Work Order ID 96980

Item Name: Crosstube Turning Detail

DRAWING NO. D407-667-145	TITLE CROSSTUBE ASS'Y (407 HIGH FWD)	REV. C	DART AEROSPACE LTD ENGINEERING ORDER		D.E.O. NO. D407-667-145-C-1	SHEET NO. SHEET 1 OF 1	SCALE NTS
DRAWN 40	CHECKED ASS	MFG. APPR. iB	APPROVED WD		DE APPR. H		
DATE 11.07.15	DATE 11.07.22	DATE 11.07.22	DATE 11/07/22		DATE 11.07.21

DRAWING NO. D407-667-145	TITLE CROSSTUBE ASS'Y (407 HIGH FWD)	REV. C	DART AEROSPACE LTD ENGINEERING ORDER	D.E.O. NO. D407-667-145-C-2	SHEET NO. SHEET 1 OF 1	SCALE NTS
DRAWN AJ5	CHECKED [Signature]	MFG. APPR. [Signature]	APPROVED [Signature]	DE APPR. [Signature]		
DATE 12.08.02	DATE 12.08.02	DATE 12.08.02	DATE 12.08.02	DATE 12.08.02	DATE 12.08.02

**SECTION R-R****DETAIL P**
BONDING STRAP INSTALLATION 2 PL

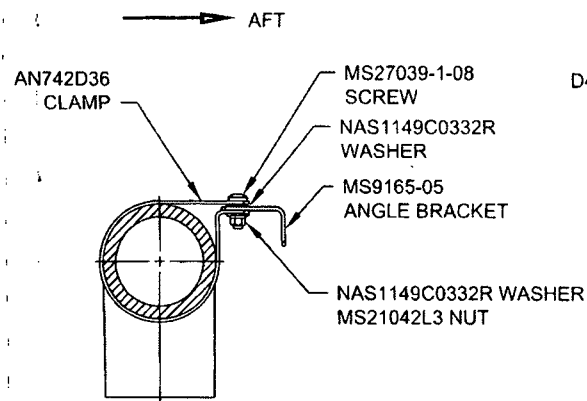
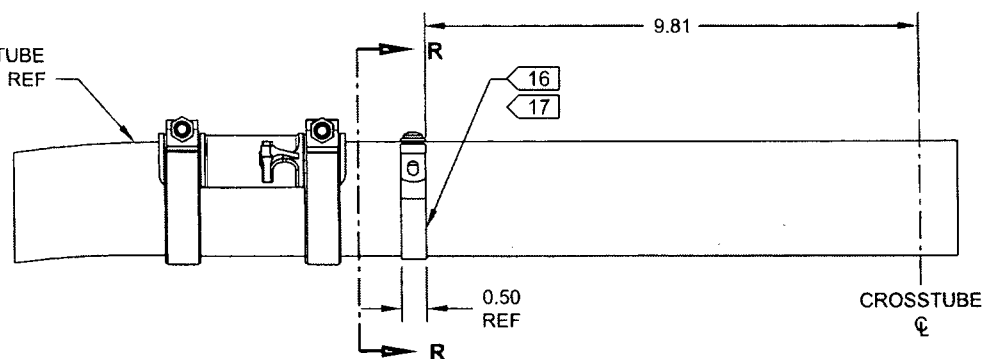
ADD ELECTRICAL GROUNDING STRAP

ITEM	QTY -145	PART NUMBER	DESCRIPTION
1	X	D407-667-145	CROSSTUBE ASSEMBLY (407 HIGH FWD)
10	2	AN742D36	CLAMP
11	2	MS9165-05	ANGLE BRACKET
12	2	MS21042L3	NUT (OR MS21042-3)
13	2	MS27039-1-08	SCREW
14	4	NAS1149C0332R	WASHER (OR AN960C10L)

- 16) MASK AREA UNDER CLAMP PRIOR TO PAINTING
 17) SEAL EDGES WHERE AN742D36 CLAMP MEETS WITH THE CROSSTUBE USING SIKAFLEX-241/-291 OR MIL-S-8802 CLASS B2 OR PROSEAL 890 SEALANT
 18) PERFORM RESISTANCE CHECK TO ENSURE MAX RESISTANCE IS 10 MILLIOHMS
